INDESIT company

Model type:
BAAN13

Commercial code:
F034171

N1030093fig1

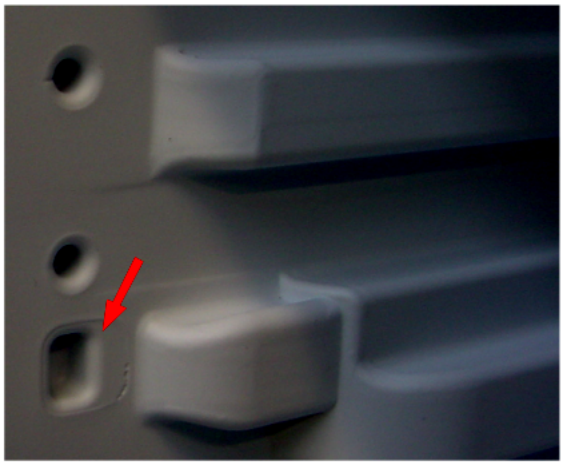
n1030093: New fixing of evaporator on static fridge-freezers (05 range) 60 cm,Melano

From August 05 (serial no. 50802.0001) the freezer evaporator is secured to the cabinet by a plastic profile.
The cabinet walls have been modified to create locations to house the profile, which is installed on the front of each evaporator plate (see photo N1030093fig1- fig2 - fig3)
The profile cannot be fitted on premodification appliances, so technical personnel must continue to fit the rh and lh supports on these models (see photo N1030093fig4)

New parts
C00141135 = WHITE PROFILE L=443.5 MM

Parts replaced
C00075596 = EVAPORATOR RH SUPPORT
C00075597 = EVAPORATOR LH SUPPORT

N1030093fig1

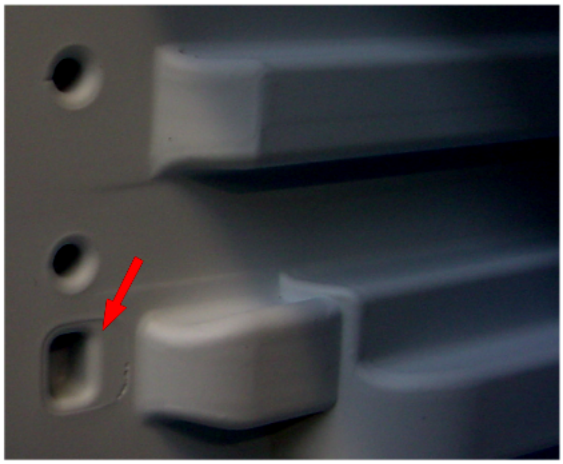
n1030094: New fixing of evaporator on static fridge-freezers (05 range) 60 cm, Lodowek

From August 05 (serial no. 50820.0001) the freezer evaporator is secured to the cabinet by a plastic profile.
The cabinet walls have been modified to create locations to house the profile, which is installed on the front of each evaporator

plate (see photo N1030093fig1- fig2 - fig3)
The profile cannot be fitted on premodification appliances, so technical personnel must continue to fit the rh and lh supports on these models (see photo N1030093fig4)

New parts
C00141135 = WHITE PROFILE L=443.5 MM

Parts replaced
C00075596 = EVAPORATOR RH SUPPORT
C00075597 = EVAPORATOR LH SUPPORT
